# WORKING PARTY ON INLAND WATER TRANSPORT (SC.3)

SC.3 CEVNI Expert Group Code: CEVNI EG/2013/16

Subject: Working document for the twenty-first meeting

The secretariat reproduces below revision and amendment proposals to CEVNI submitted by CCNR on 26 July 2013 ensuing from the work on the German version of CEVNI for consideration by the CEVNI Expert Group. Amendment proposals by the secretariat based on language discrepancies identified during the work on the German version of CEVNI are also included.

## Annex 7, section I, sign D.1

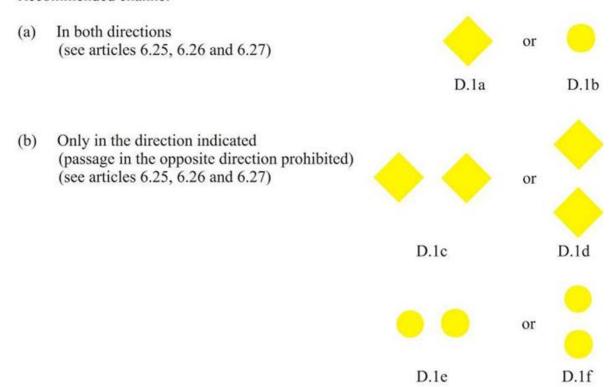
It is proposed to modify the name of the sign to "Recommended opening" instead of "Recommended channel". The present signs are as follows:

E.7.1 Berthing area reserved for loading and unloading vehicles. (Maximum duration of berthing permitted may be added on an information plate below the board)

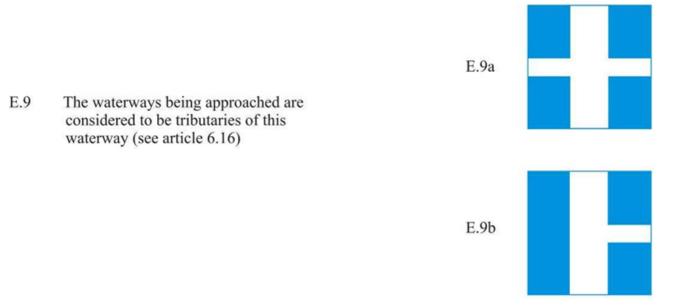
It is proposed to modify the name of the sign to "Making fast to the bank for the immediate loading or unloading of motorized vehicles". The present signs are as follows:
